INTERIM CHANGE NOTICES (ICN) FOR RESOURCE CONSERVATION AND  
RECOVERY ACT (RCRA) GROUNDWATER (GW) MONITORING PLANS

**INTERIM CHANGE NOTICE  
(ICN)**

Document Title: Combination RCRA Groundwater Monitoring Plan for the  
216-A-10, 216-A-36B, and 216-A-37-1 PUREX Crib

Document Number: WHC-SD-EN-AP-013 Revision Number: 1  
Document Title: Interim Status Groundwater Monitoring Plan for the 216-B-3 Pond  
Document's Original Author: M. D. Sweeney

**Figure 3.1. Facility Layout and Locations of Monitoring Wells for the 216-B-3 Pond System.**

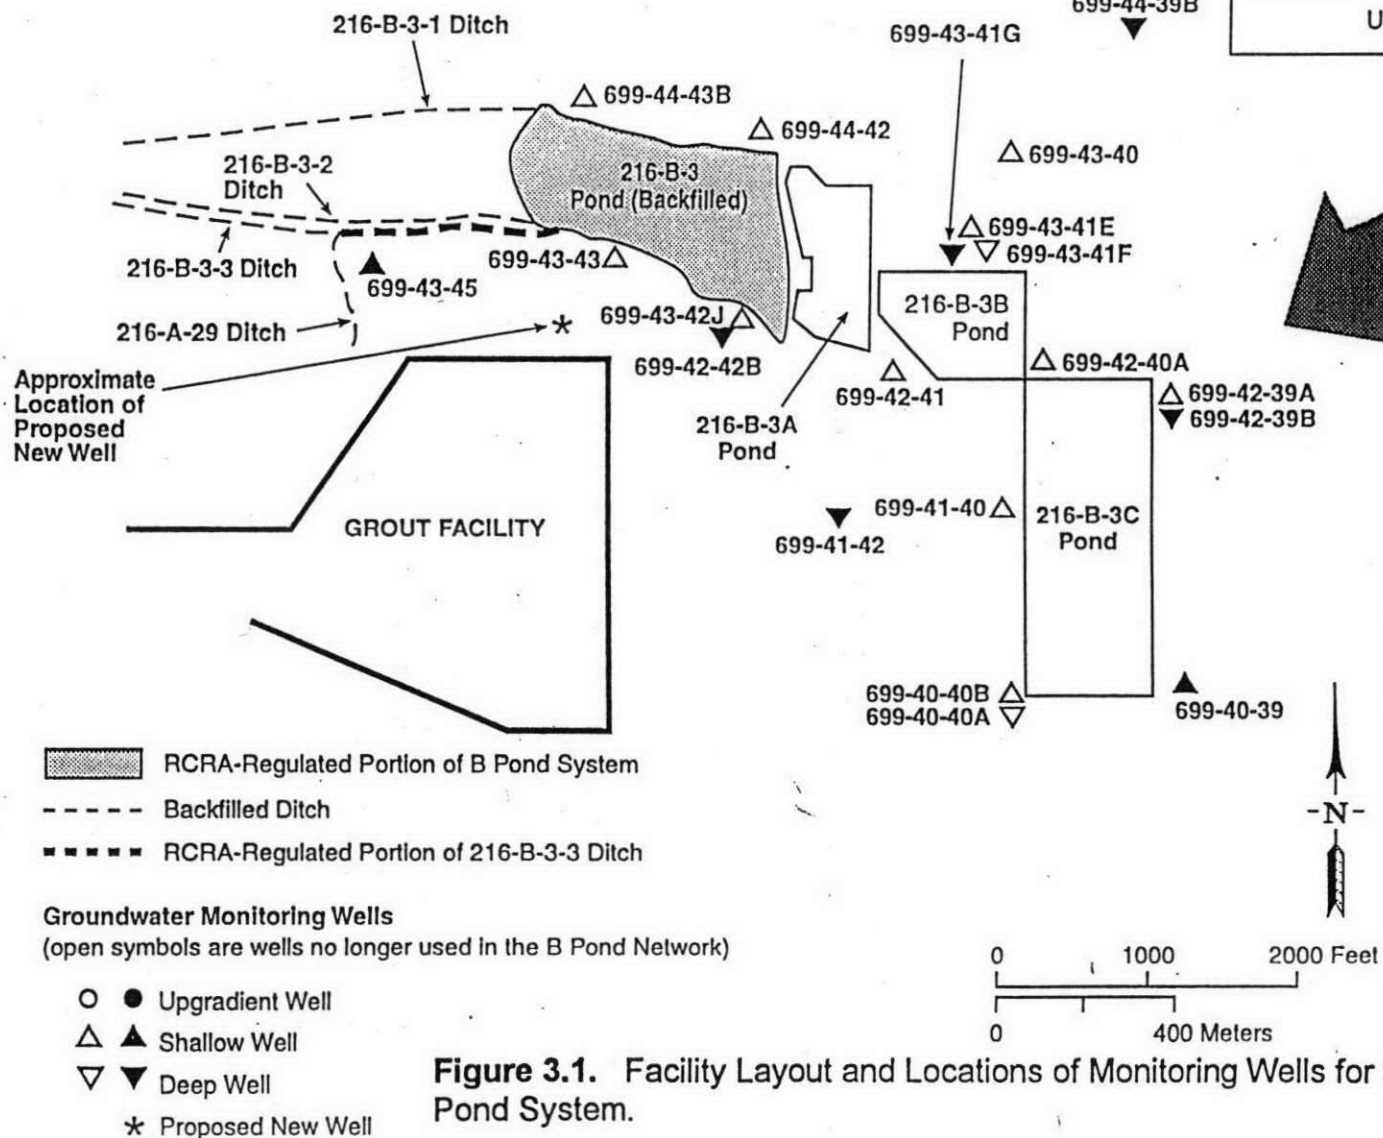
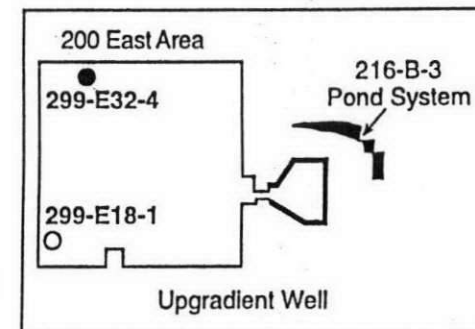
The existing array of wells around the B Pond System provide more than an adequate number of potential monitoring points from which to select. The possible exception is the area immediately southwest of the B Pond, for which a new well is proposed. The revised well network is shown in Figure 3.1. In all, 9 wells (8 downgradient) are proposed for the revised network.

A comparison of these well locations with the June 1998 potentiometric surface is shown in Figure 3.2. Well 299-E32-4, in the northwest portion of the 200 East Area, will remain as the upgradient monitoring location.
